**AGENDA OF THE CITY COUNCIL MEETING
FOR THE CITY OF HAYDEN, KOOTENAI COUNTY, IDAHO**

Agenda Item: Authorize Change Order No. 5 with LaRiviere, Inc. for the Honeysuckle Avenue and Ramsey Road Roundabout Project for changes related to private utility delays and conflicts, pedestrian access revisions, a deductive adjustment for water facility testing, a deductive adjustment for resident project representative costs for Saturday work, and a time adjustment to ensure that added contract days fall on working days for a net cost decrease of \$6,108.43 and twelve (12) added contract days.

CONTRACT CHANGE ORDER NO. 5

CONTRACT CHANGE ORDER NO. 5
TO
41014.14 - HONEYSUCKLE AVENUE AND RAMSEY ROAD ROUNDABOUT IMPROVEMENTS

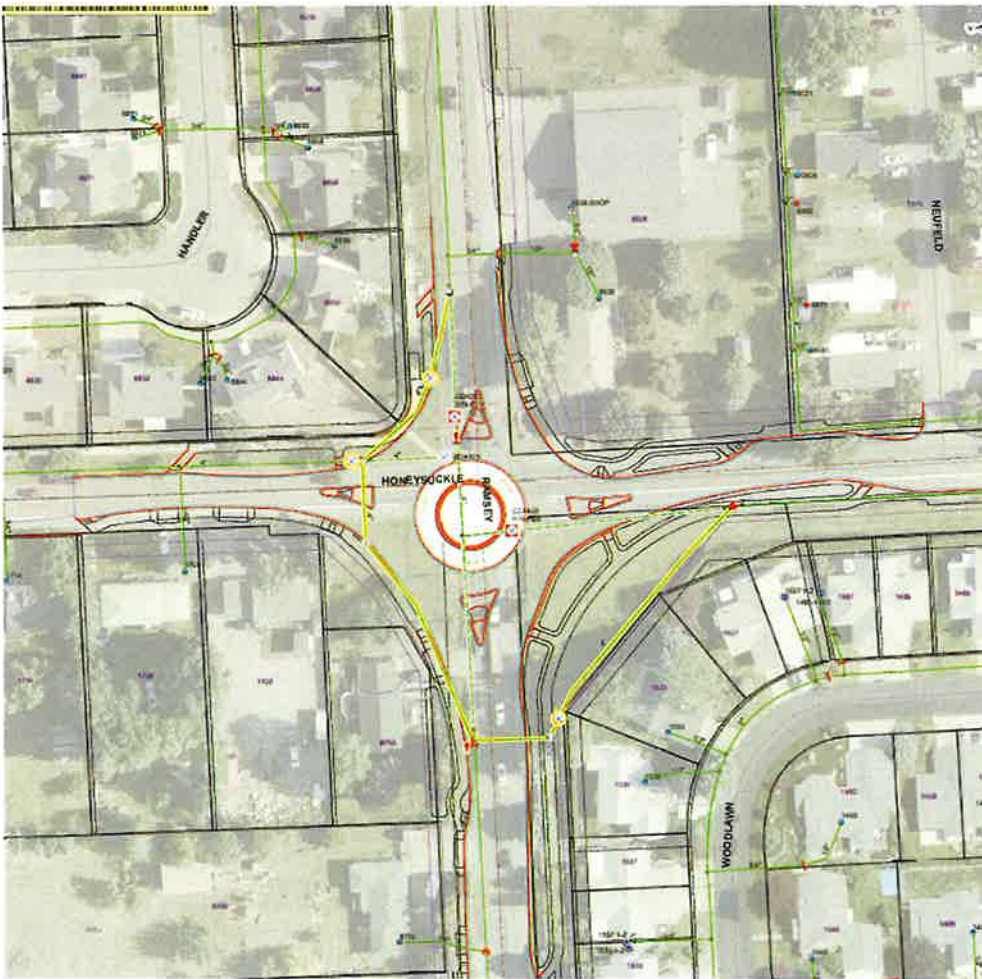
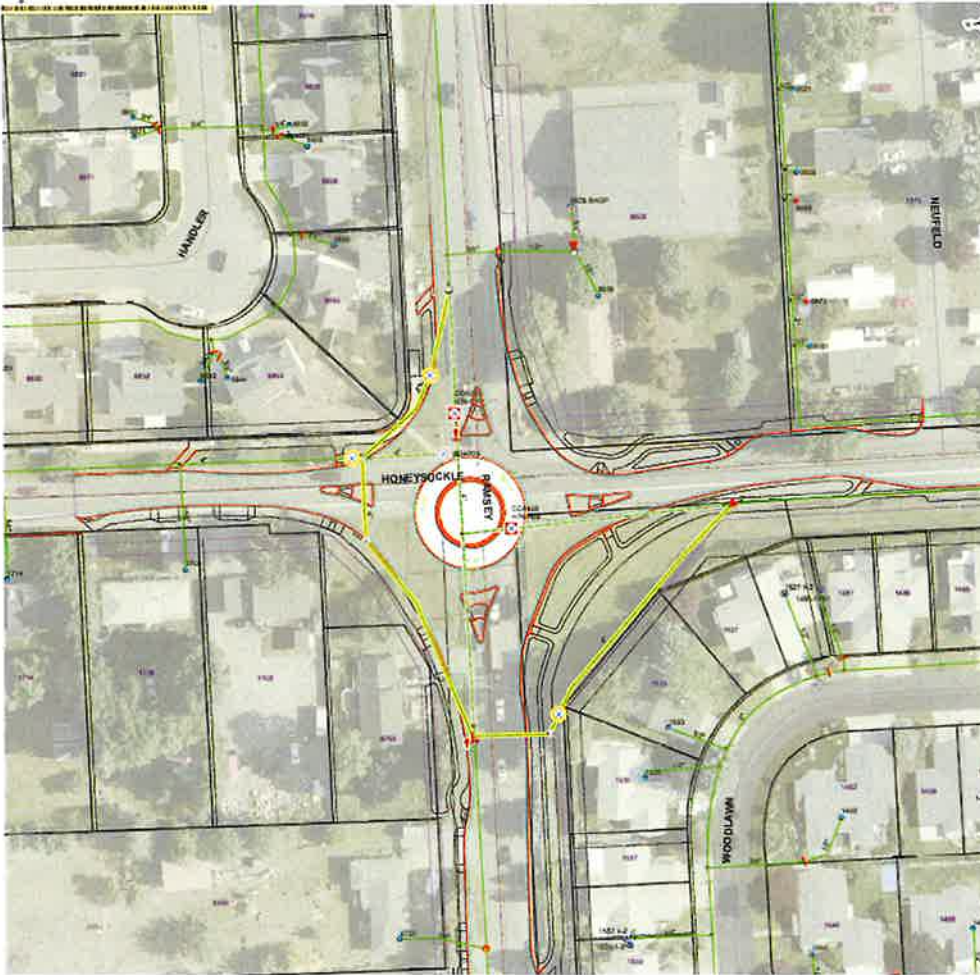
The north leg of the intersection, past the roundabout, was changed from its original design to be lowered in grade. The attached exhibit shows the new roadway profile and how it drops below EG from Station 38+25 to 41+00. The low point of the road is marked on the sheet, and from talking with Jason Stippich earlier today it sounds like they are digging a parallel trench to the existing gas main and dropping it a max of 2' at the low point if they can manage that.

WORK CHANGE PROPOSAL REQUEST NUMBER: 2

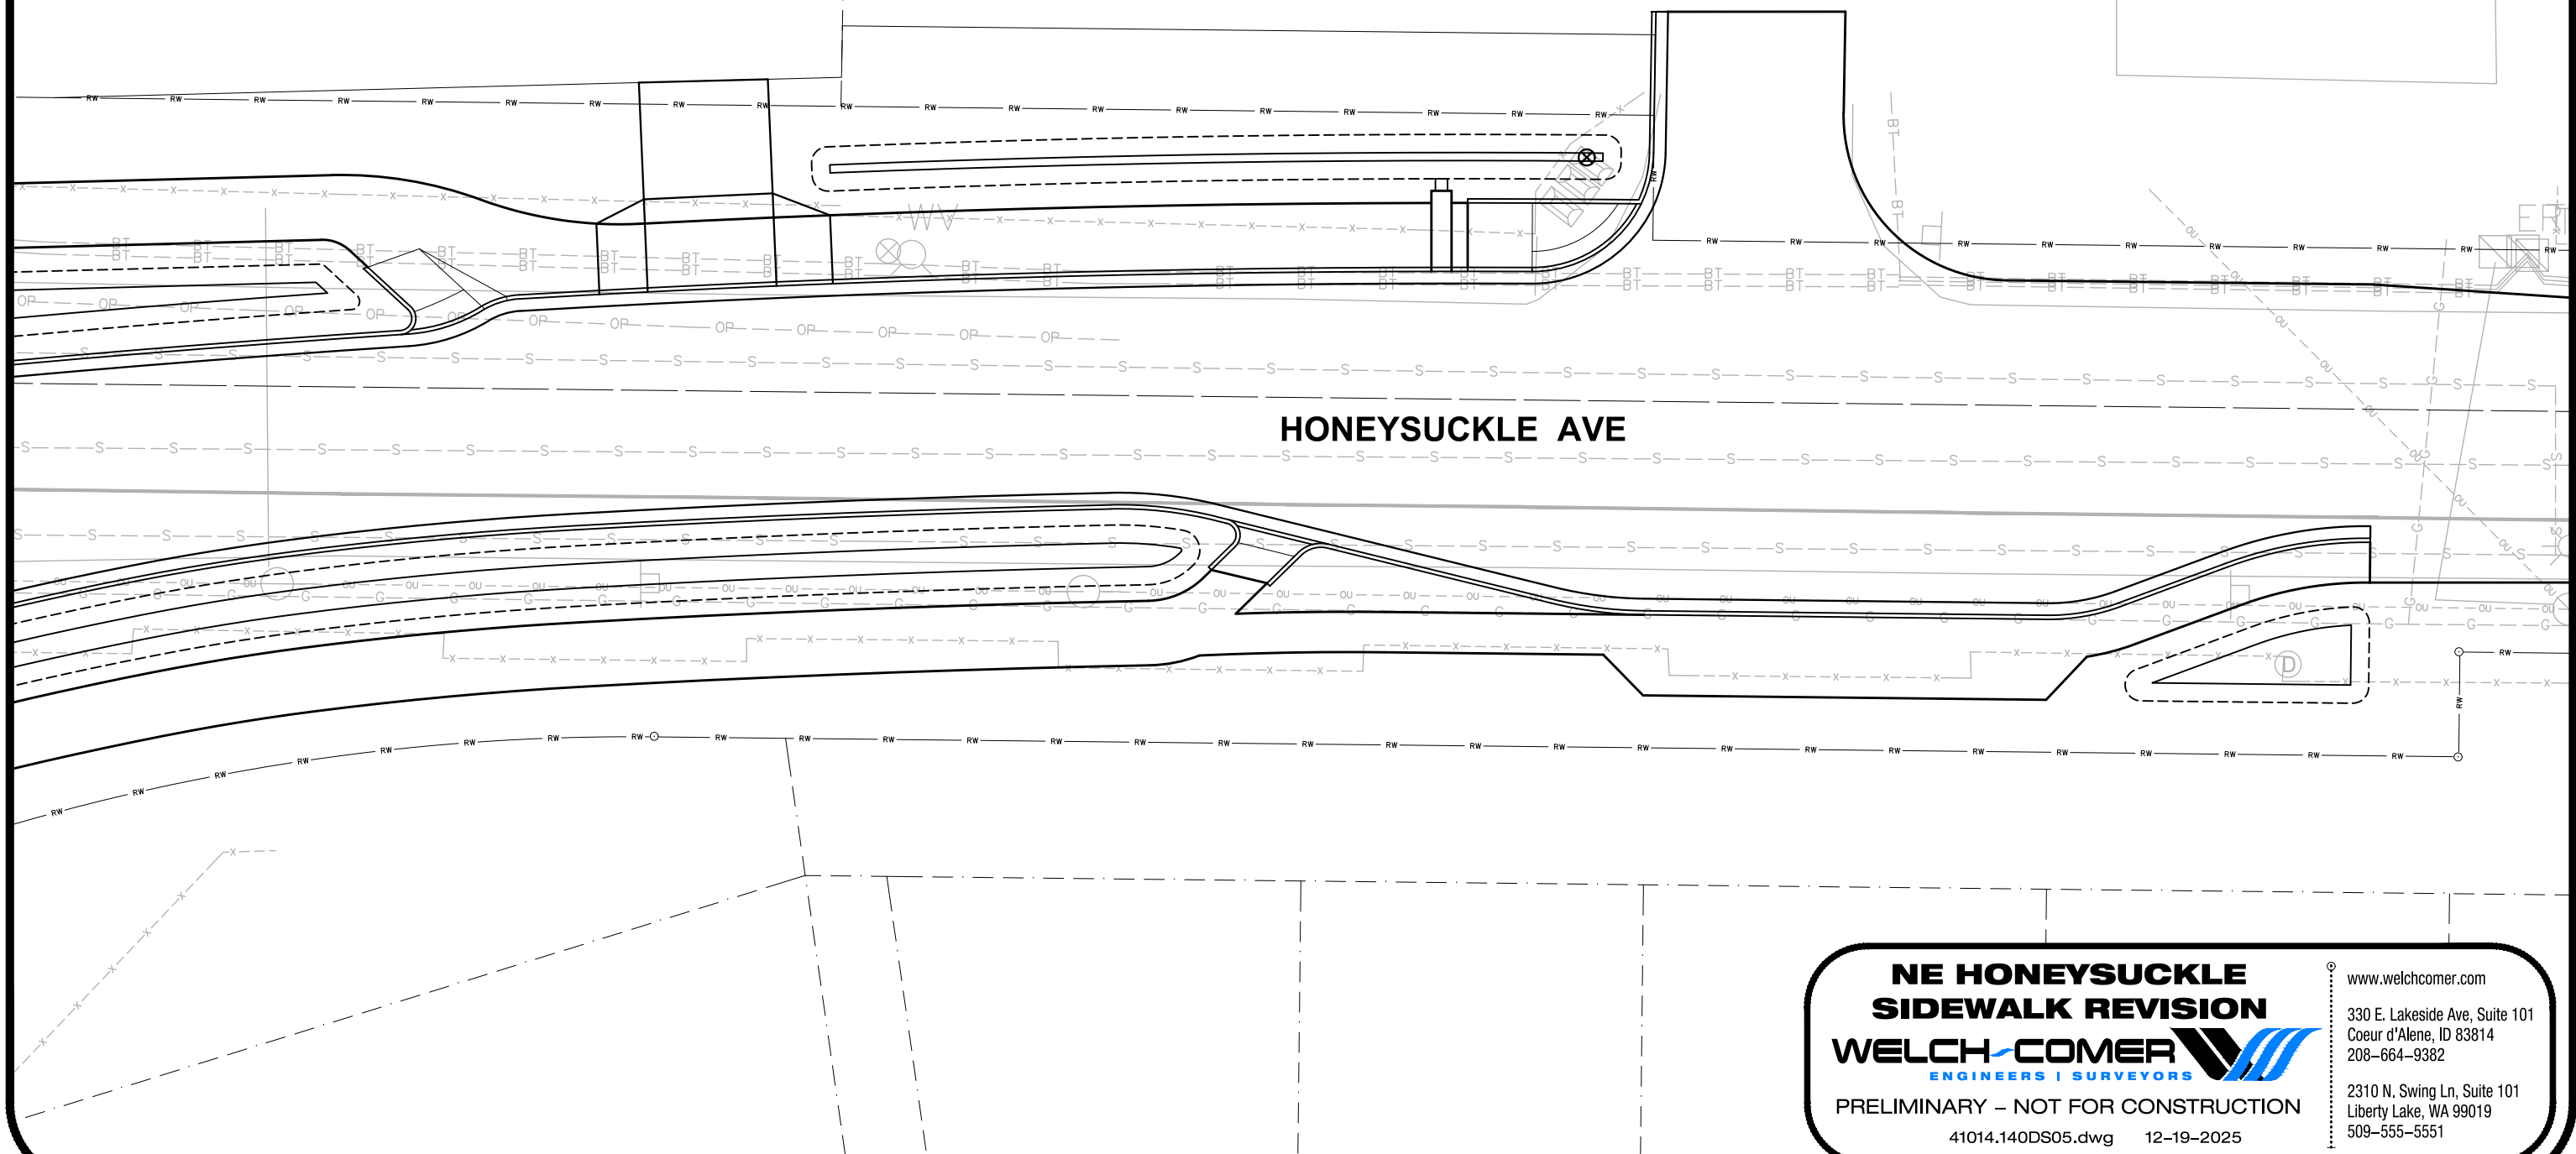
The sidewalk was changed from separated from the curb to adjacent to the curb. This requires relocation of the drywell, increasing the sidewalk from 5' wide to 8' wide, change in type of approach, change in types of ped ramps, and the addition of a sidewalk underdrain.

While the increase in sidewalk width, change in ped ramp type, ped curb, and change in approach type can be handled with unit costs. We need a cost for the underdrain because this is larger than the other one in the project. Note the City of Hayden standard plan requires the underdrain to be 2 feet wider than the sidewalk to extend from the face of curb to 18" beyond back of walk.
